Economic Commission for Europe

Special session of the WP.24 on the CTU Code

Consultations on updates to the Code of Practice for Packing of Cargo Transport Units

Proposed updates to the Code of Practice for Packing Cargo Transport Units

Figure 1.31.2 Typical sales contract term

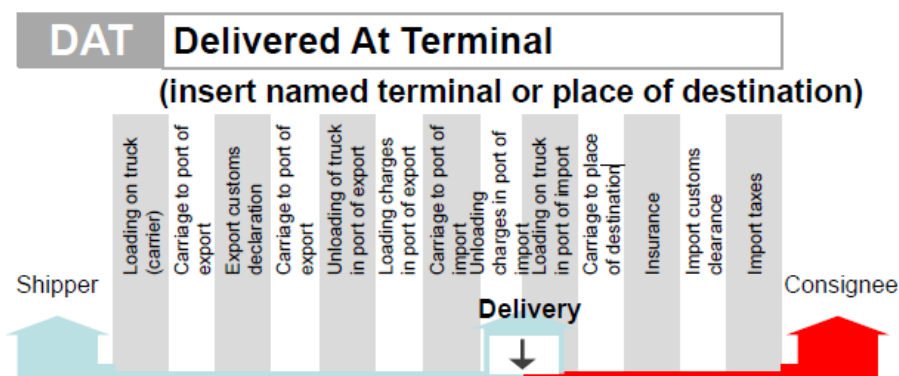
8.17.1 Figure 1.3 shows a typical INCOTERM published by the International Chamber of Commerce. Under this contract the shipper is responsible for all aspects of transport up until the CTU is unloaded at the port of import.

Figure 7.3 Centre gap with transverse ~~bracing~~**blocking**

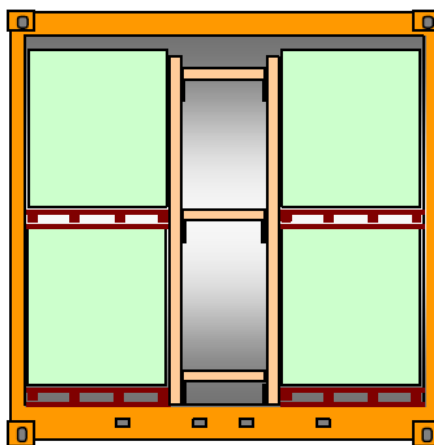
2.3.1 Blocking, ~~bracing or shoring~~ is a securing method, where **either the cargo is stowed directly against strong structural elements of the CTU or additional materials**, e.g., timber beams and frames, empty pallets or dunnage bags **are used to filled in the gaps** between the cargo and solid boundaries of the CTU or ~~into~~ gaps between different packages (see figure 7.3). Forces are transferred in this method by compression with minimal deformation. ~~Inclined bracing or shoring arrangements bear the risk of bursting open under load and should therefore be properly designed.~~ In CTUs with strong sides, **and where if possible**, packages should be stowed tightly to the boundaries of the CTU on both sides, leaving the remaining gap in the middle. This reduces the forces to the ~~bracing~~**blocking** arrangement, because lateral g-forces from only one side will need to be transferred at a time.

Figure 7.75 Properly cut and nailed wedges

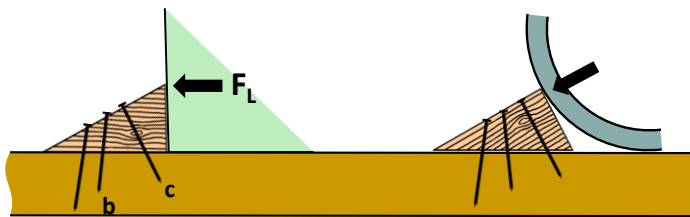
2.3.5 Blocking by nailed-on scantlings that is secured using mechanical fastenings on bedding or spreader beams should be used for minor securing demands only. **The different types of fixing will provide a range of shear strength**, depending on the **type, configuration and size of the nails** fastener used. **For example, the shear strength of such a blocking arrangement secured using nails may be estimated to take up a blocking force between 1 and 4 kN per nail.** Nailed on wedges may be favourable for blocking round shapes like pipes. Care should be taken that wedges are cut in a way that the direction of grain supports the shear strength of the wedge. Any such timber beams or wedges should only be nailed to bedding beams or timbers placed under the cargo (see figure 7.5). Wooden floors of closed CTUs are generally not suitable for nailing. Nailing to the softwood flooring of flatracks or platforms and open CTUs may be acceptable with the consent of the CTU operator (see figure 7.7).

Figure 7.27 Tarpaulin used solely to prevent small and light packages from falling out when stowed close to the door.

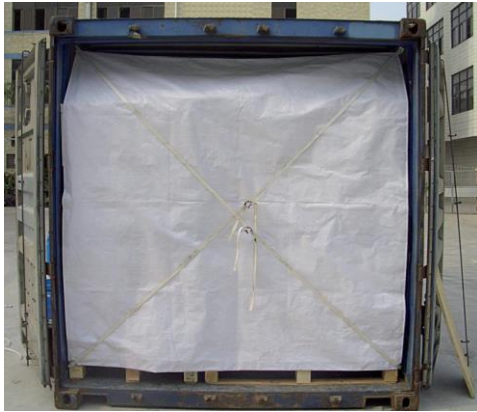
~~materials (solids and liquids), small hand-packed packages and pallets with low integral stability, the doors should not be used as the only mean to constrain the cargo as there is a risk of the cargo falling onto those who open the CTU for inspection or unpacking. In such cases the cargo should in addition be restrained~~ A possible falling out of cargo can be prevented by spring lashing (see Figure 7.5859), a modular lashing system (see Figure 7.26), a tarpaulin (see Figure 7.27) or nets or net-curtains (see Figure 7.28).~~using shoring bars / rear false bulkhead (see clause 5.3.3.4).~~

Figure 7.2942 Packing 1,000 x 1,200 mm unit loads into a 20-foot container

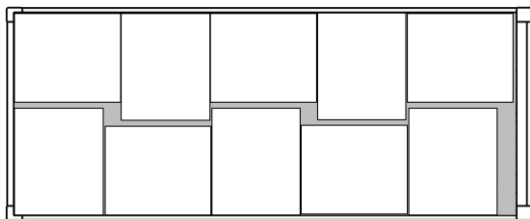
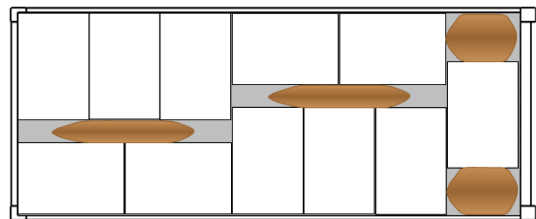
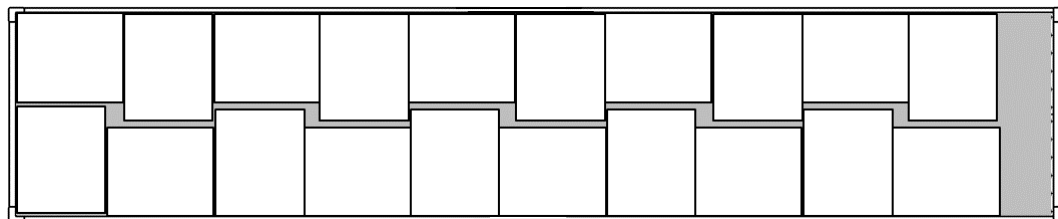
4.23.2 A tight stow of uniform or variable cargo items should be planned and arranged according to principles of good packing practice, in particular observing the advice given in ~~clause section~~ 3.24 of this annex. If coherence between items or tilting stability of items is poor, additional measures of compacting may be necessary like hooping or strapping batches of cargo items with steel or plastic tape or plastic sheeting. Gaps between cargo items or between cargo and CTU boundaries should be filled as necessary (see ~~clause subsections~~ 2.3.67 to 2.3.810 of this annex). Direct contact of cargo items with CTU boundaries may require an interlayer of protecting material (see ~~clause section~~ 2.1 of this annex).

Note: The void areas (grey shaded) shown in figures 7.2942 to 7.3144 should be filled when necessary (see **clause subsection 2.3.67** of this annex).

Figure 7.6398

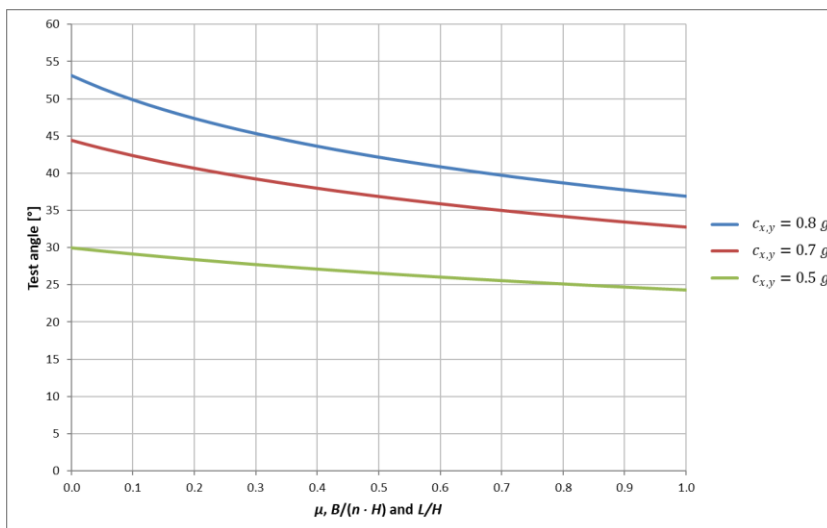
If μ and $\frac{B}{n-H}$ is 0.3 ~~at~~ **for sideways accelerations sideways at** transport in sea area B ($c_y = 0.7g$) the cargo securing arrangement should be able to be inclined to approximately 39°, according to ~~the diagram~~ **figure 7.98 and table 7.15**

Figure 7.69 - Positioning flexitanks

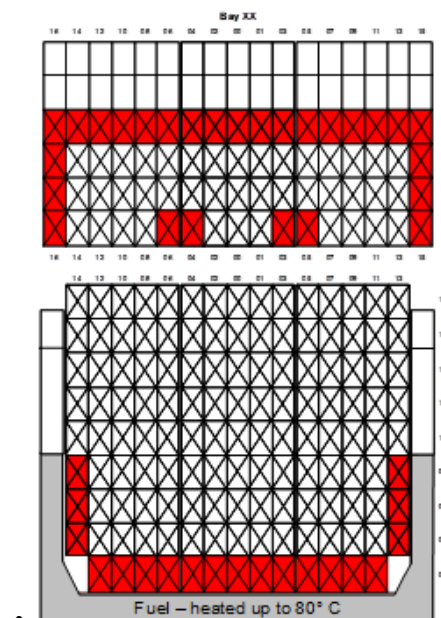
- Temperature sensitive cargoes⁴ should not be placed on or near heated bunker tanks, the elevated temperature required to keep the fuel viscosity low may heat or otherwise damage the cargo (red slots below deck in figure 7.69).

- Above deck, CTUs (containers) with flexitanks should not be stowed in the outer and upper most slots as or at the edges of deck covers (red slots above deck in figure 7.54 as:
